ADDENDUM NO. 1

DATE: March 27, 2020

FROM: Baxter & Woodman, Inc., Consulting Engineers

VILLAGE OF HOFFMAN ESTATES, ILLINOIS  
CHIPPENDALE LIFT STATION REHABILITATION

**G-1**

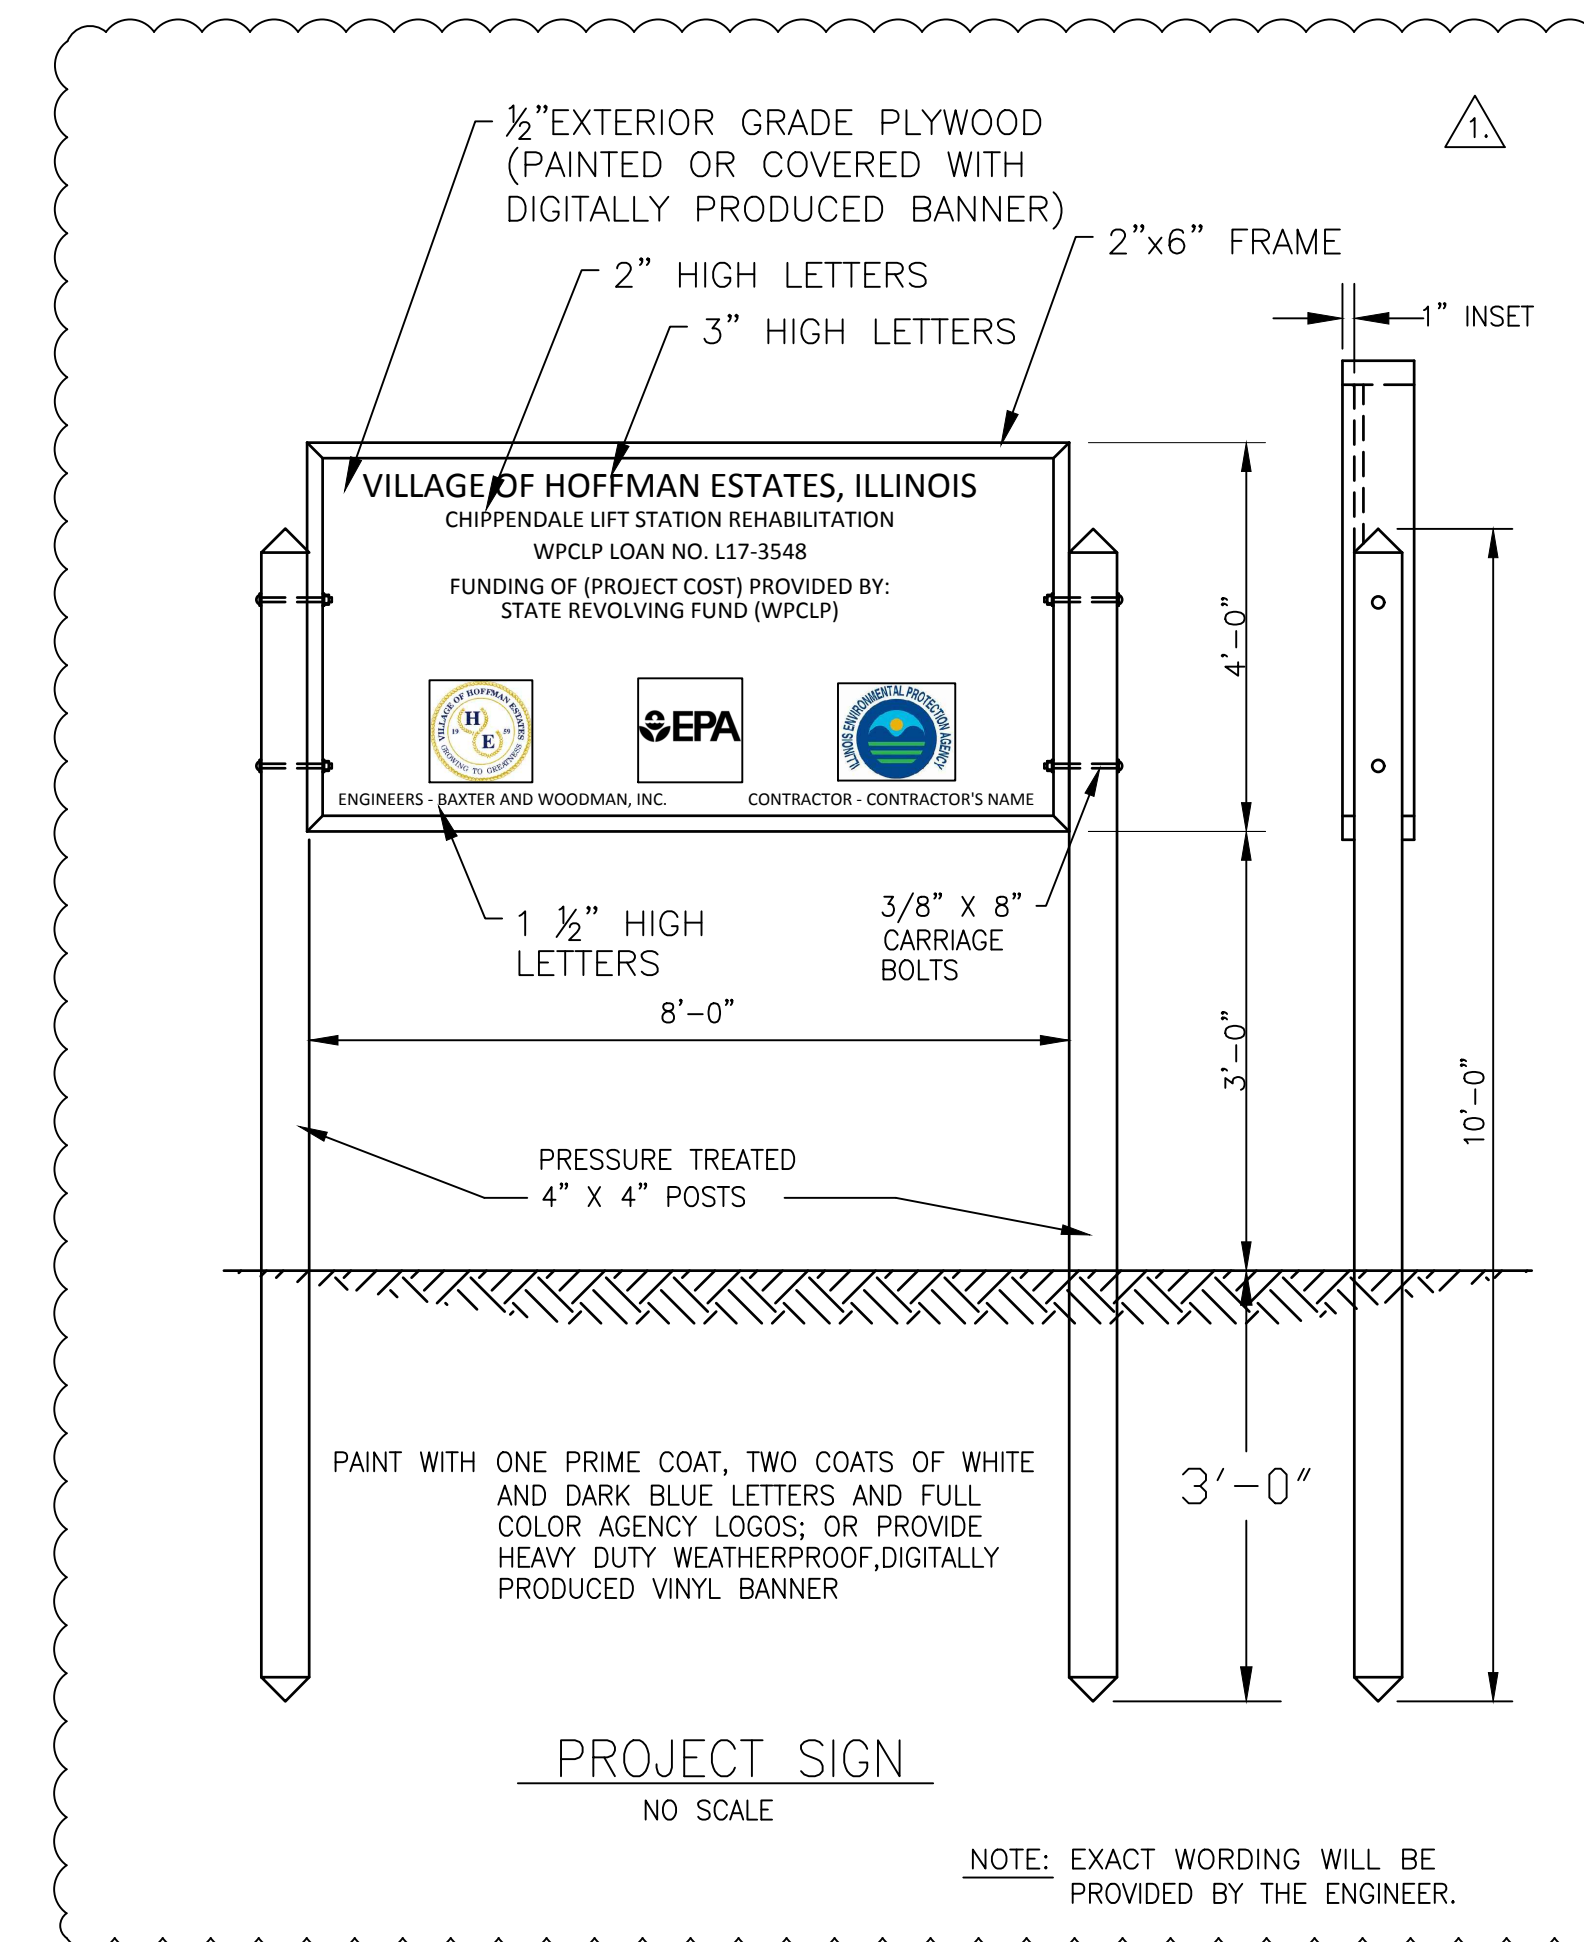
- A. Delete Sheet G-1 in its entirety, and insert attached Sheet G-1, revision dated March 26, 2020 in lieu thereof.

Revision to add IEPA Project Sign Detail.

**C-1**

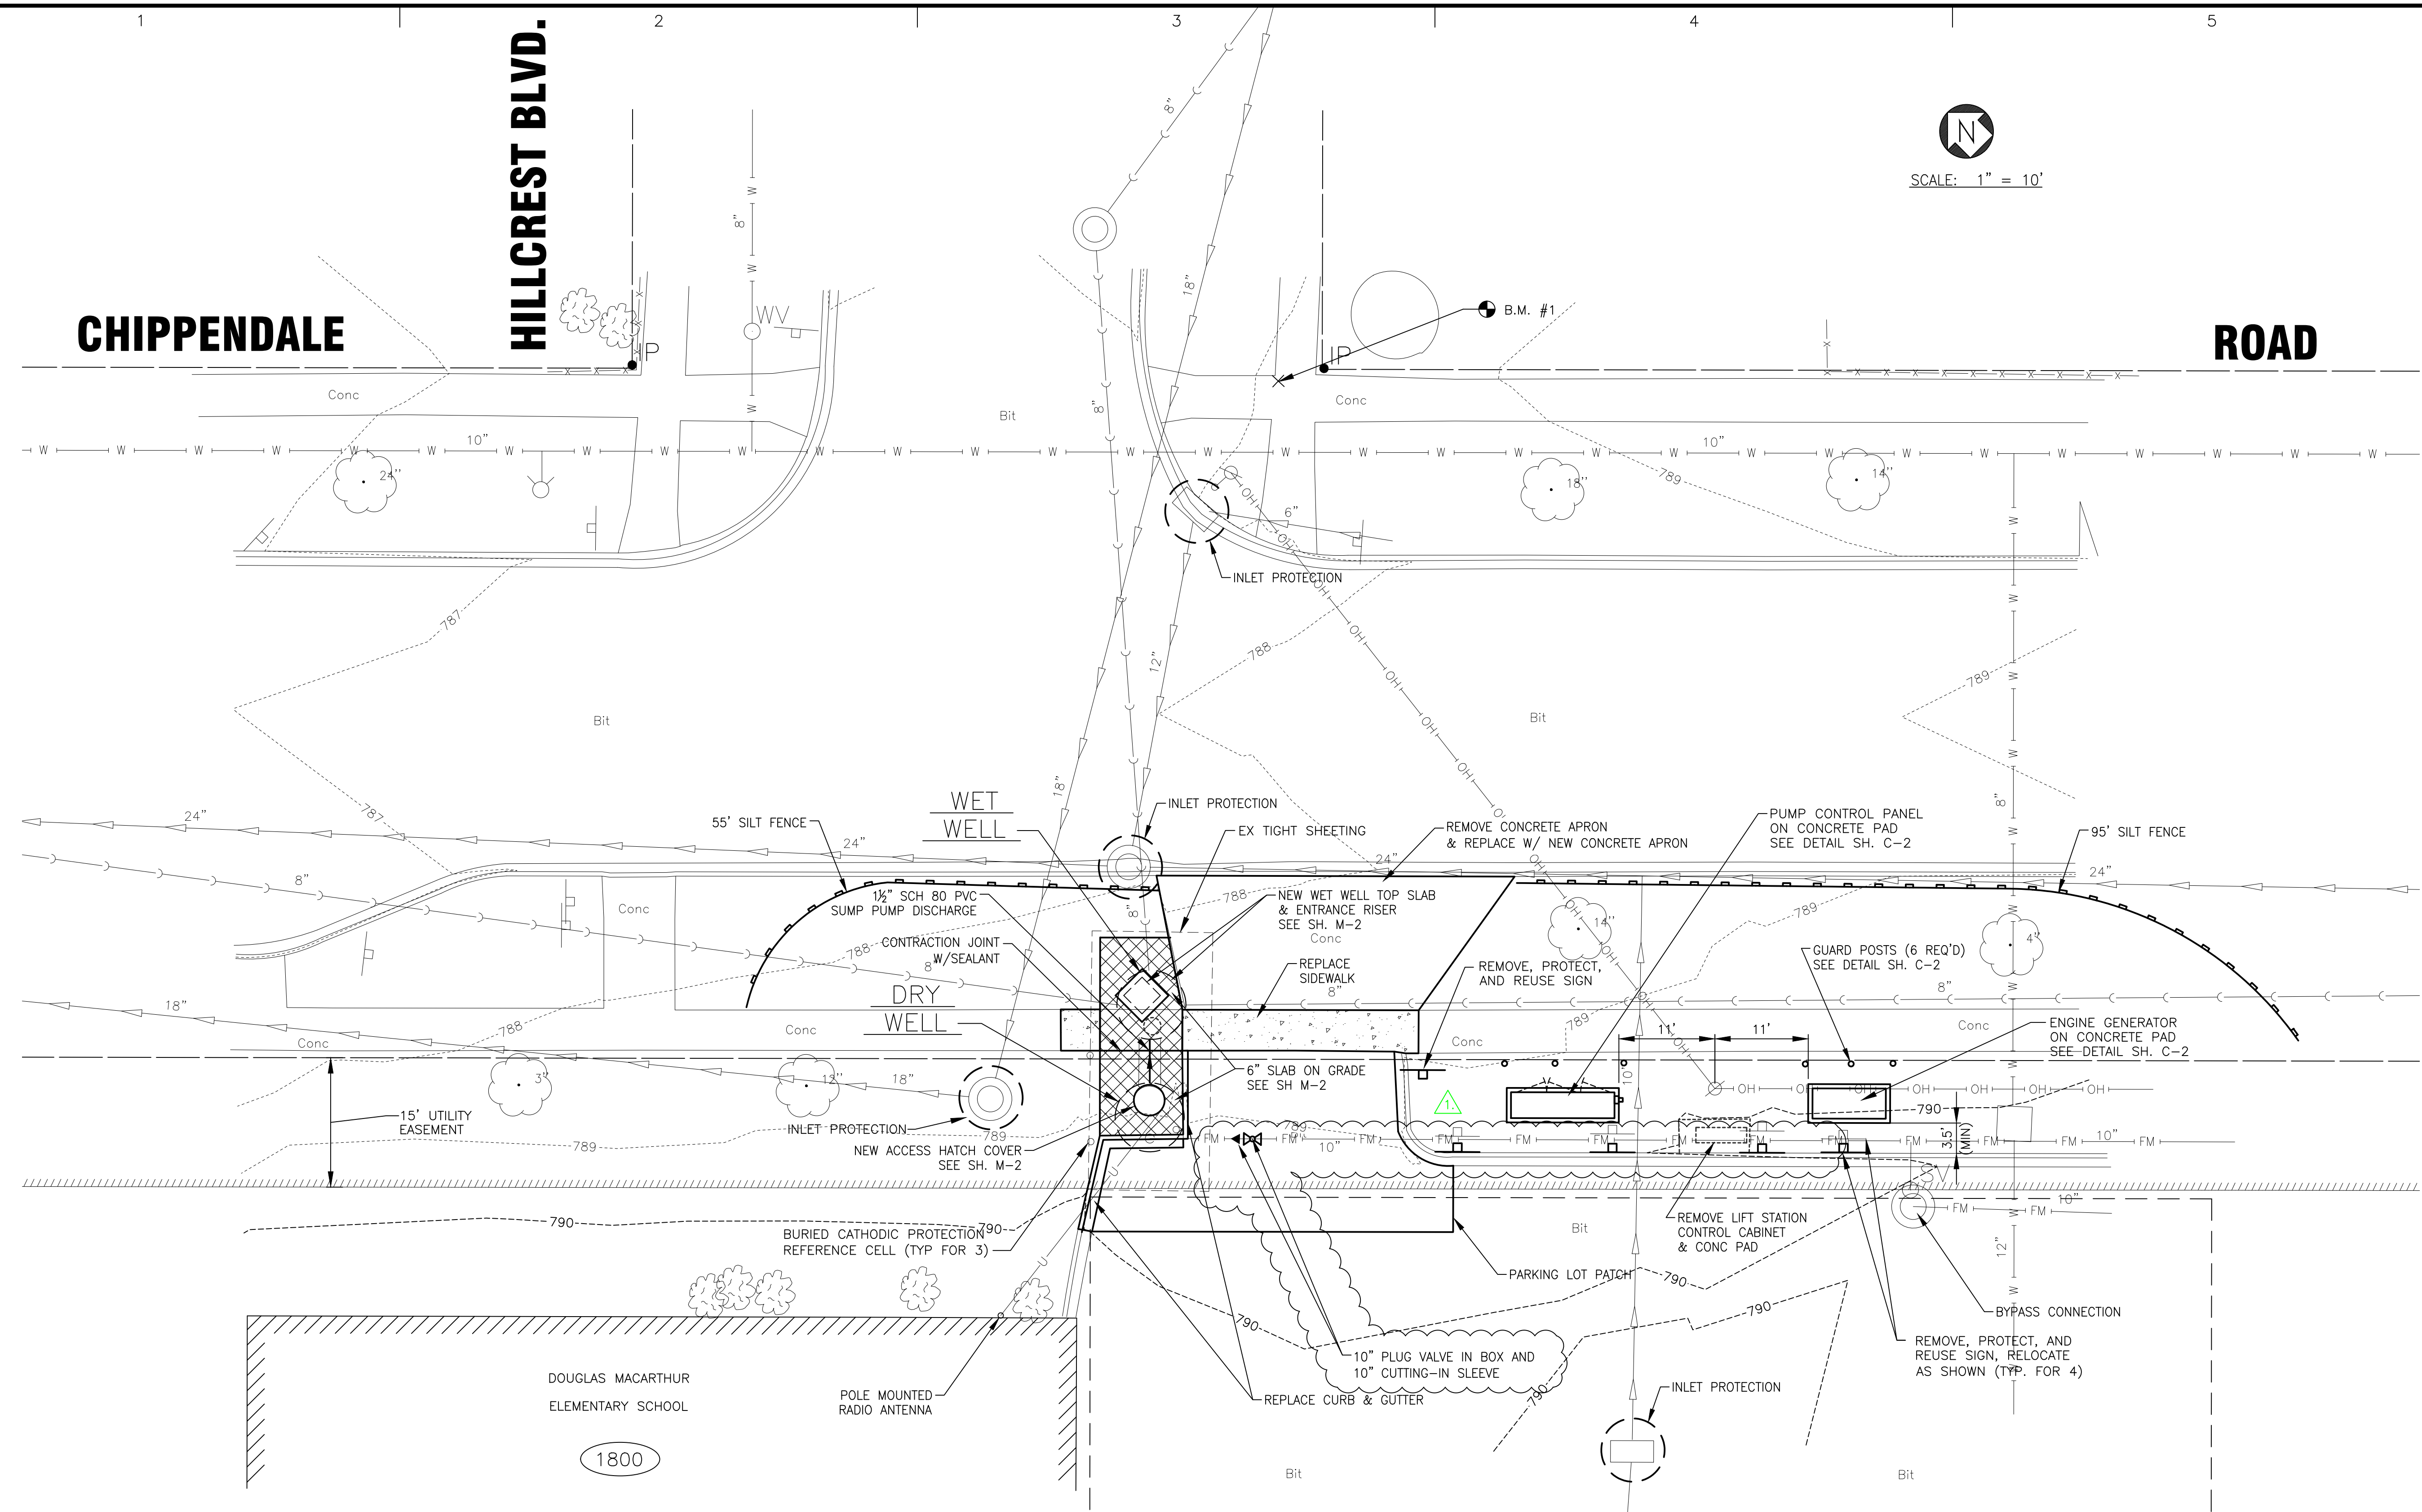
- B. Delete Sheet C-1 in its entirety, and insert attached Sheet C-1, revision dated March 26, 2020 in lieu thereof.

Revision to realign existing force main; and to move plug valve, sleeve, and change required restoration.
